AGENDA FOR REGULAR COUNCIL MEETING ON **THURSDAY**, **AUGUST 23**, **2018 6:00 P.M.** ALTOONA CITY COUNCIL CHAMBERS

ALTOONA PLAN COMMISSION – 2018-0813 APPLICATION FOR REZONING –N Hillcrest Parkway

PLANNING DEPARTMENT STAFF REPORT

SPECIFIC IMPLEMENTATION PLAN - PREVEA HEALTH

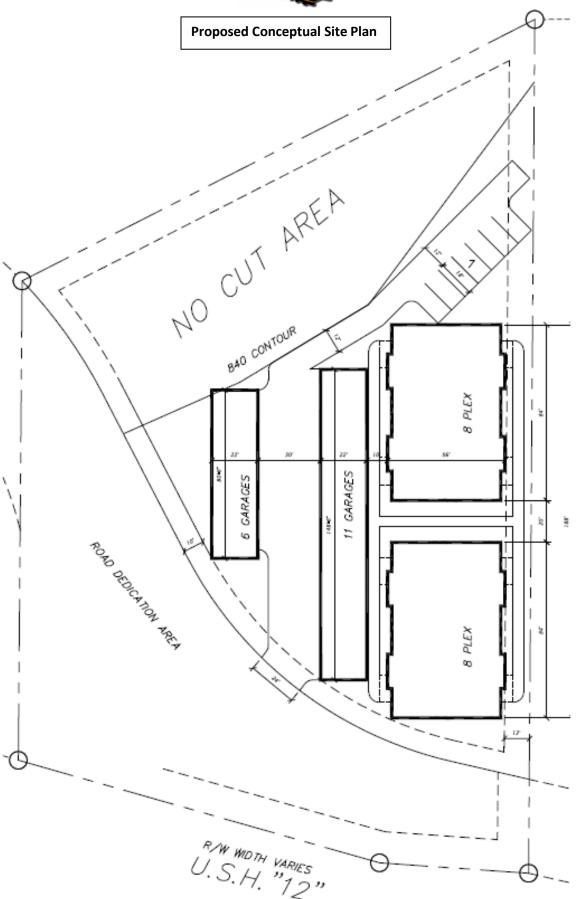
The proposal will need to obtain approval of storm water permit and site plan approval. The existing site is wooded with significant slope. The water dynamics of the site is resulting in erosion carrying sediment into the WI DOT HWY 12 ditchline and adjacent private property. This erosion would be corrected by an approved Site Plan.

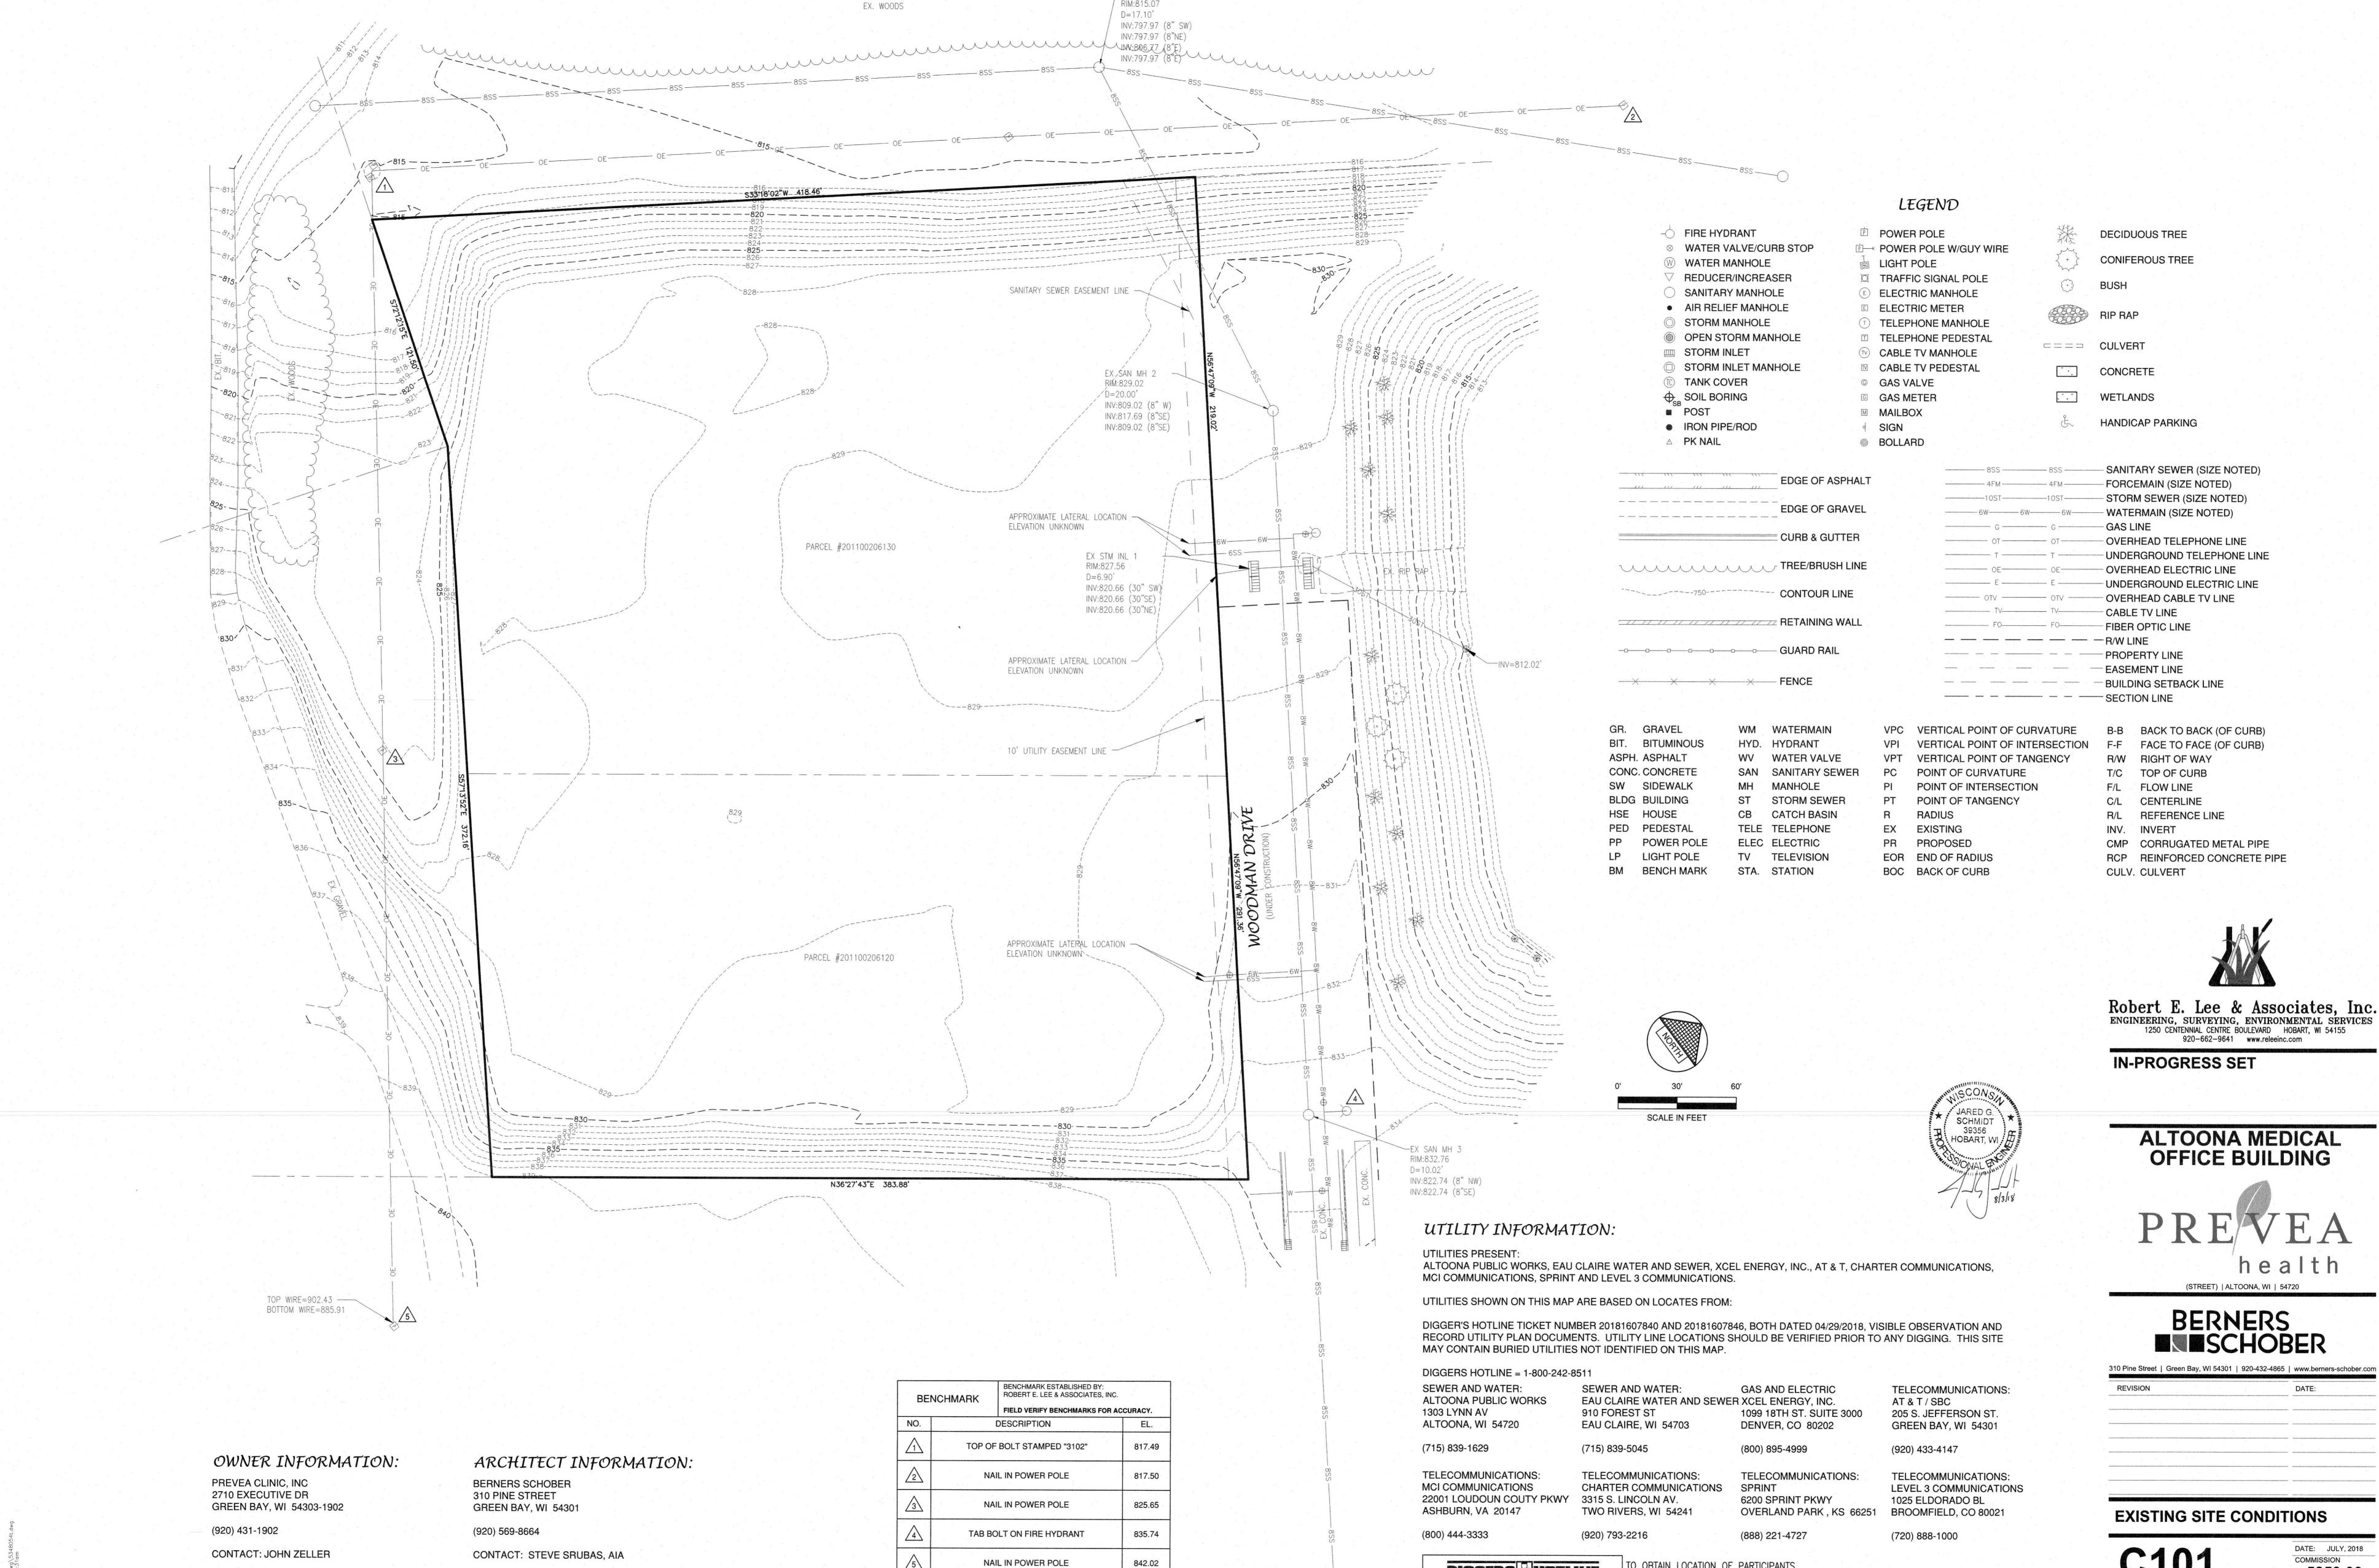
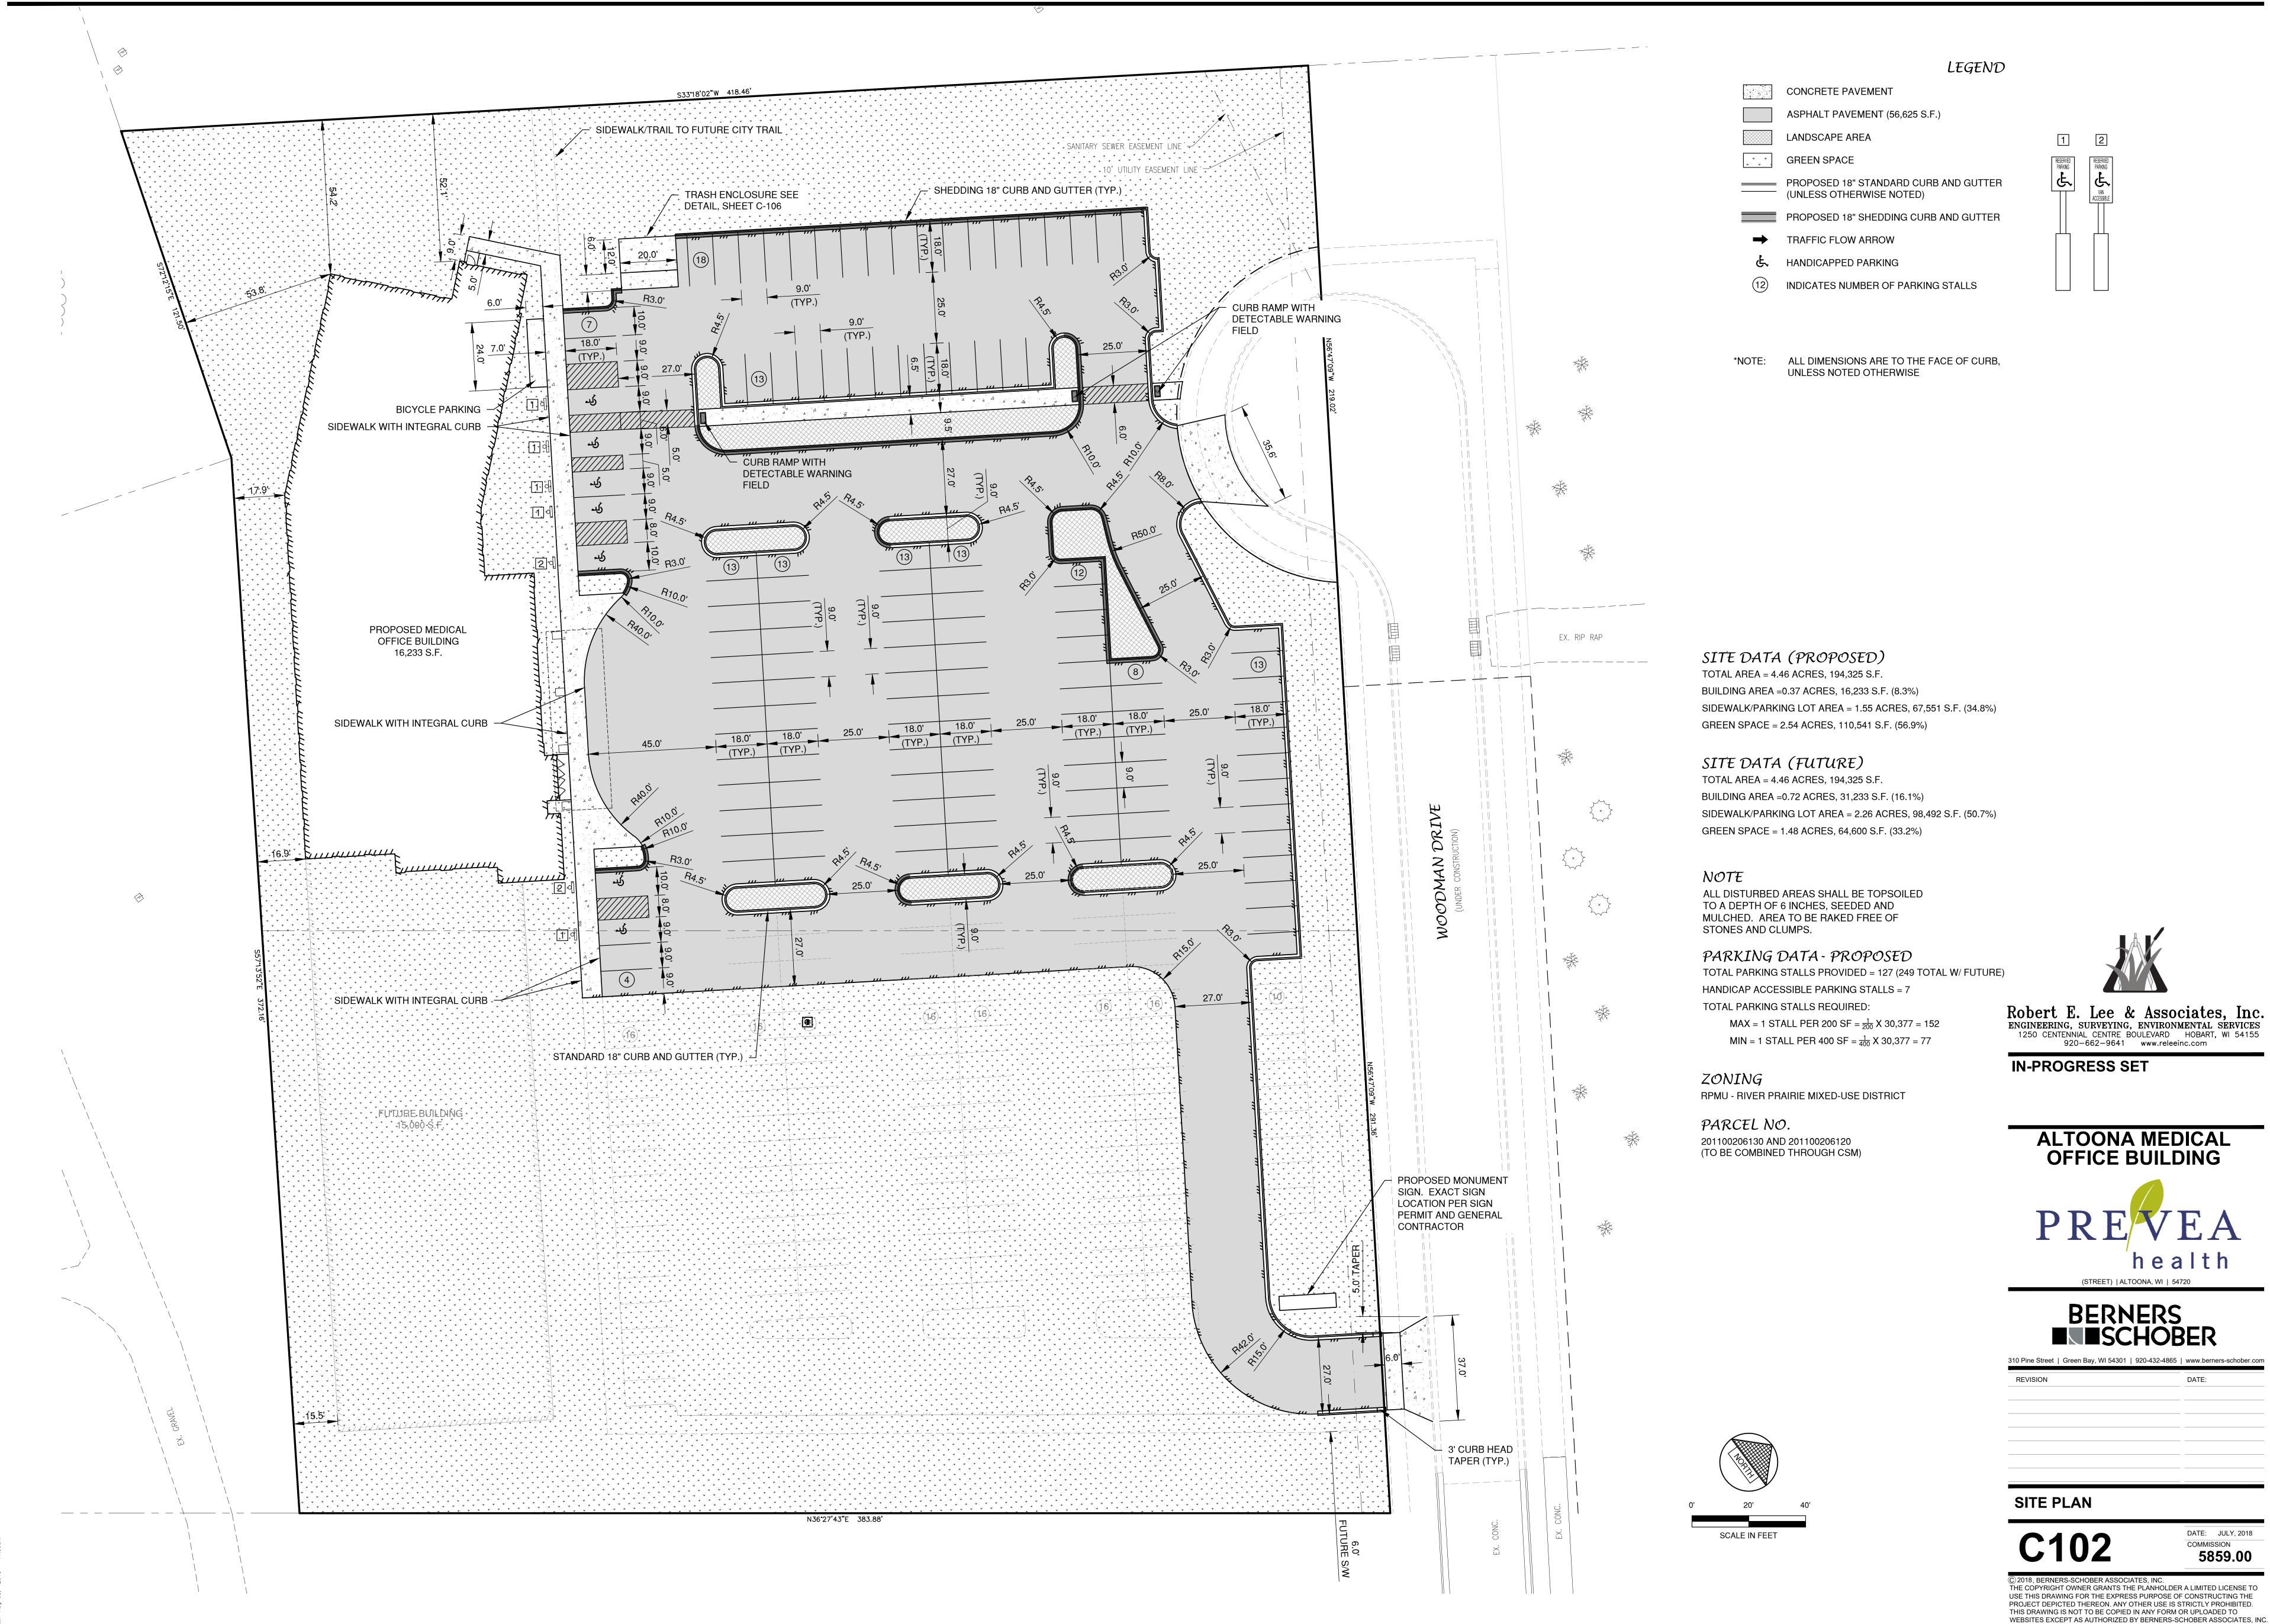
- 1. Site Plan as proposed generally provides adequate pedestrian connection to existing and planned public walkways, as required by the River Prairie Design Guidelines. Material layout of the designated pedestrian walkway shall be continuous (concrete) as it crosses through the parking lot and drive isles, with a break in the continuity of the parking area paving and not the pedestrian access way [RPDG IX. 1 (C)(5)b].

- 2. Foundation plantings shall be provided around the front (north) of the building at least three feet wide along not less than fifty percent of the frontage [RPDG IX 6 (E)(2)].

- 3. Parking lot islands shall be landscaped, including canopy shade trees, to maximize area of shading [RPDG IX 6 (E) (5)] not less than one per 150 sf² of island area. The parking lot islands shall feature appropriate and attractive plant selections, including appropriate selection of tree species.

- 4. Native canopy trees shall be planted between the parking area and Woodman's Drive at not greater than 25-foot average spacing [RPDG IX 6 (D), (E), (G)].

- Native canopy trees shall be planted in the parking area boulevard between the designated pedestrian
 walkway through the automobile drive isle at not greater than 25-foot average spacing [RPDG IX 6
 (D), (E)(5), (G)].

- 6. Native canopy trees shall be planted along the western edge of the parking area at not greater than 40-foot spacing [RPDG IX 6 (D), (E), (G)] with species selection and placement in recognition of the slope.
